City of Albuquerque

RE: REVISED DRAINAGE PLAN FOR CANADA PUMP STATION
(F-23/D6) REVISION DATED DECEMBER 4, 1990

TOPOGRAPHIC SURVEY OF
LOT 14, BLOCK 14, UNIT 2
GLENWOOD HILLS SUBDIVISION

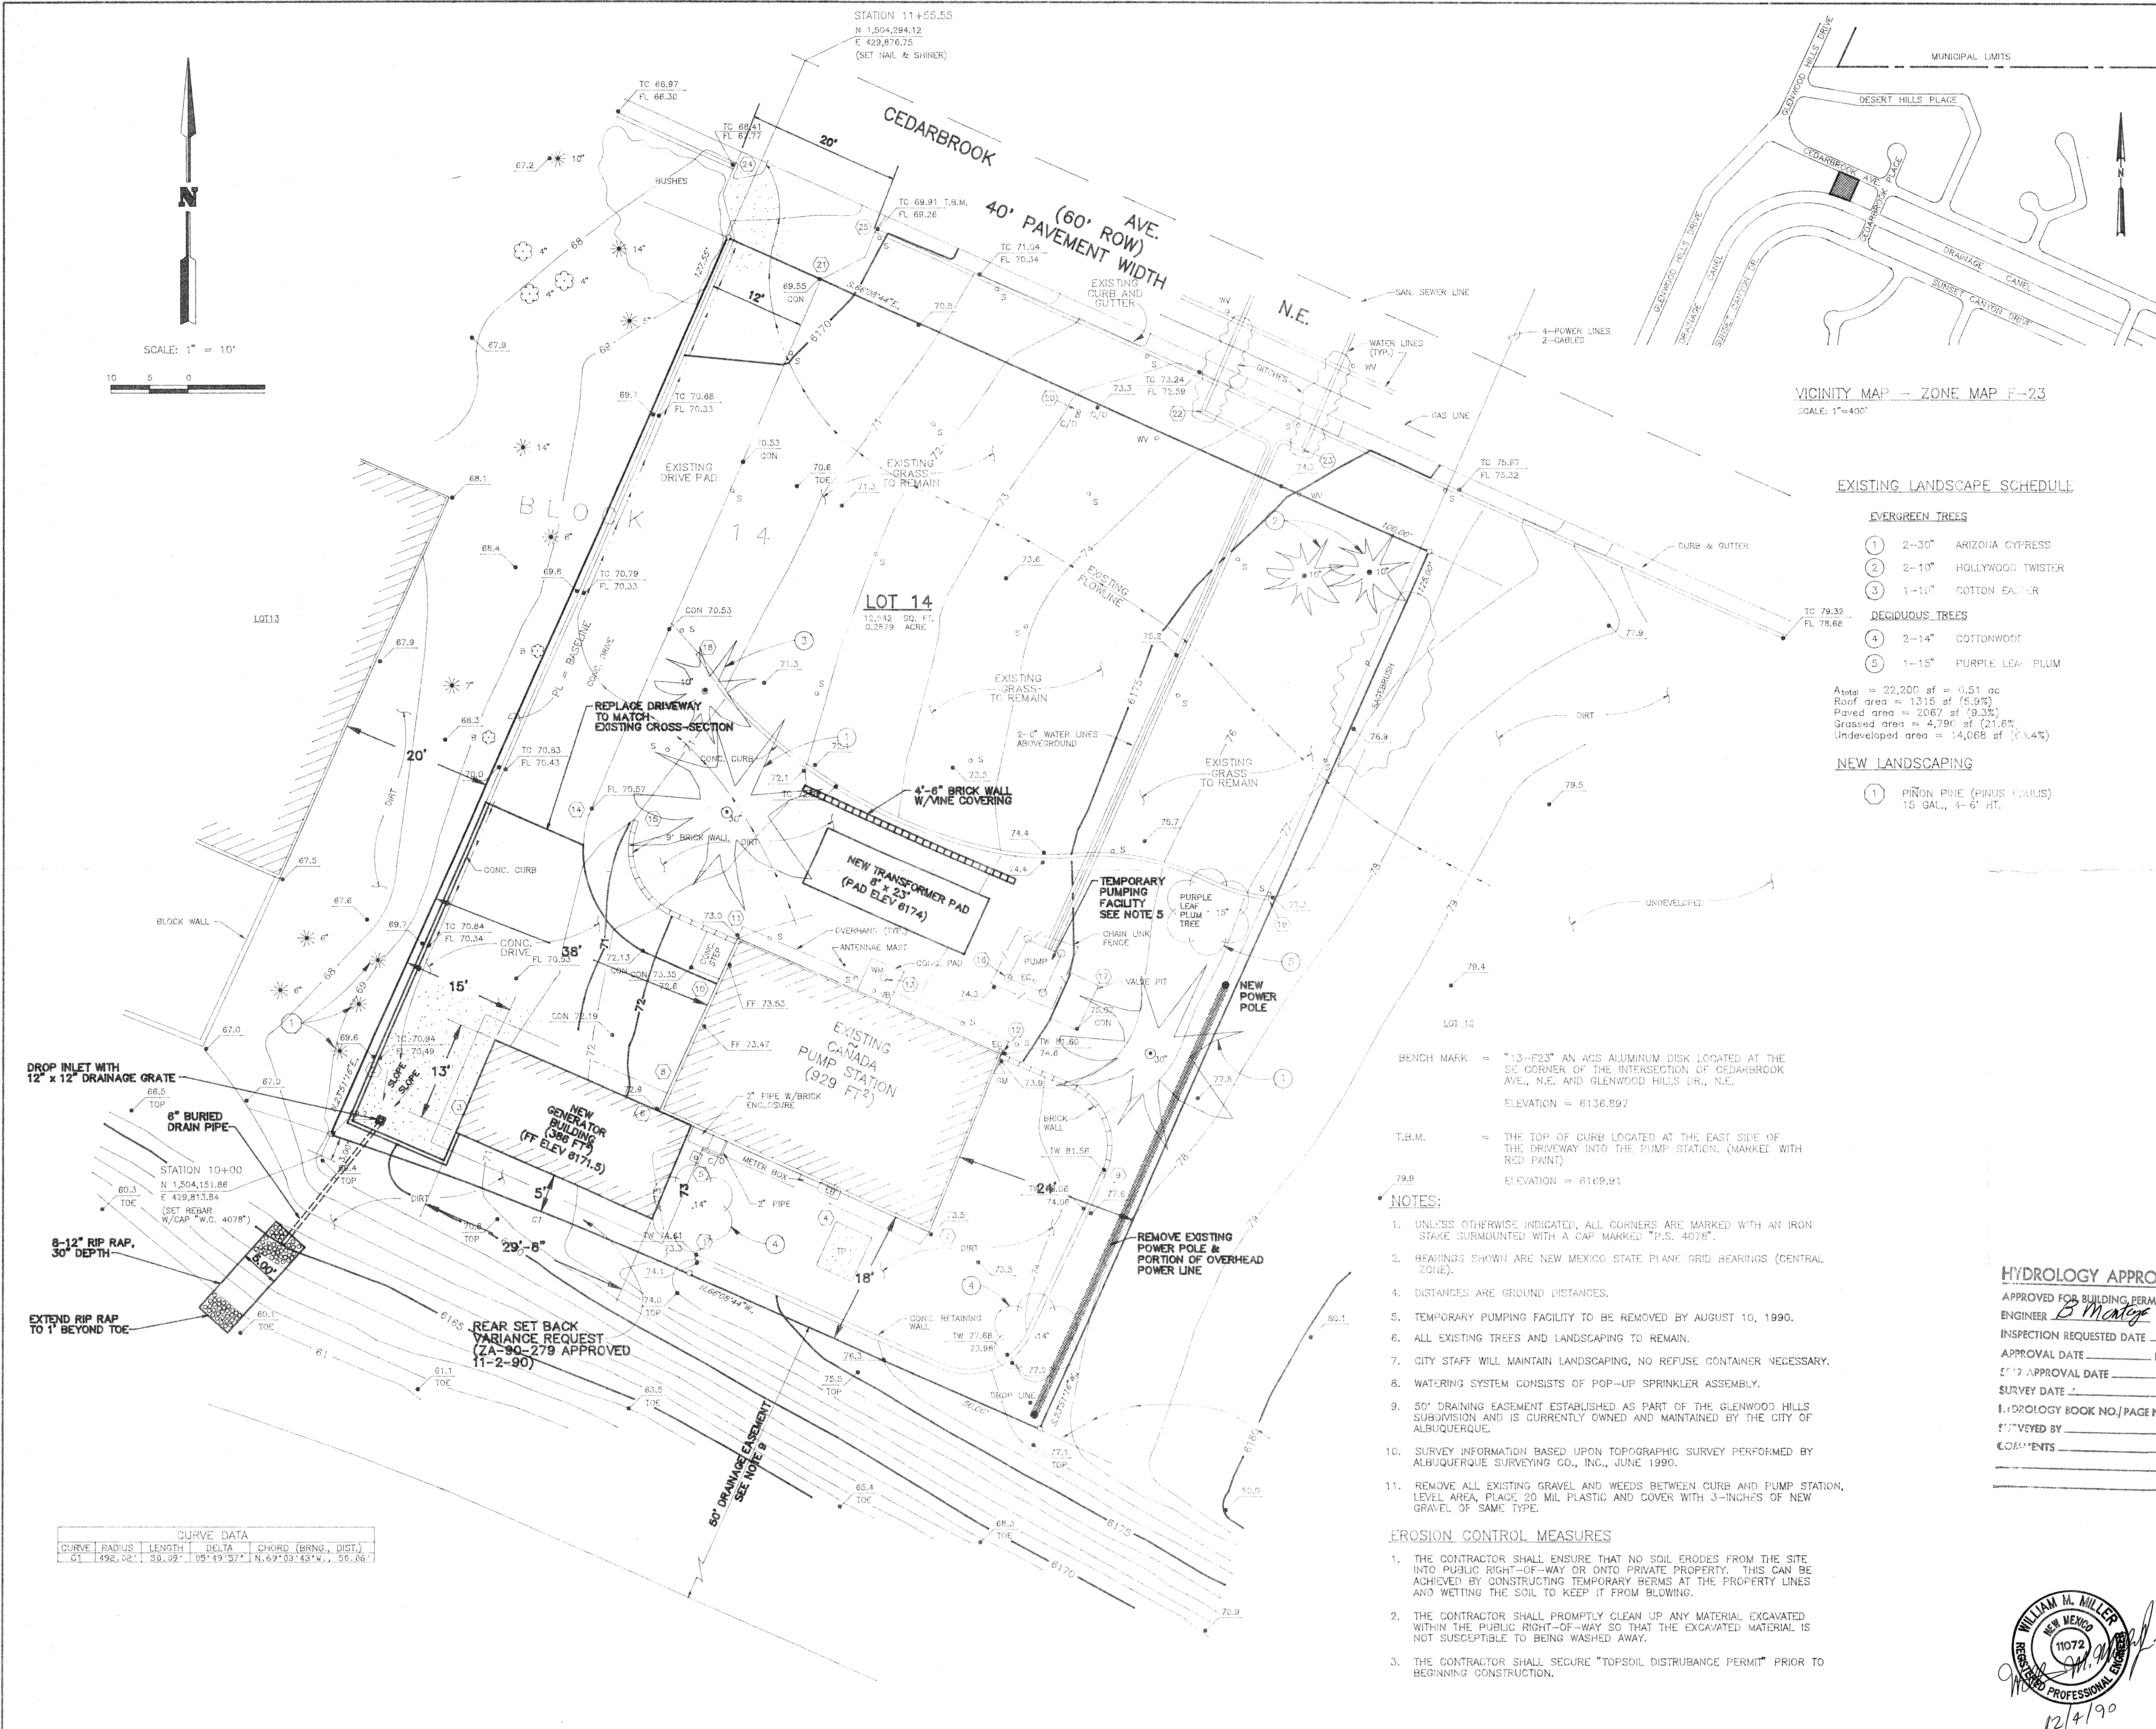
Based on the information provided on your resubmittal of December 5, 1990, the above referenced plan is approved for Building Permit.

Please attach a copy of this plan to the construction sets prior to sign-off by Hydrology.

Also, prior to Certificate of Occupancy release, a copy of the Letter of Acceptance for the Work Order must be submitted for our files.
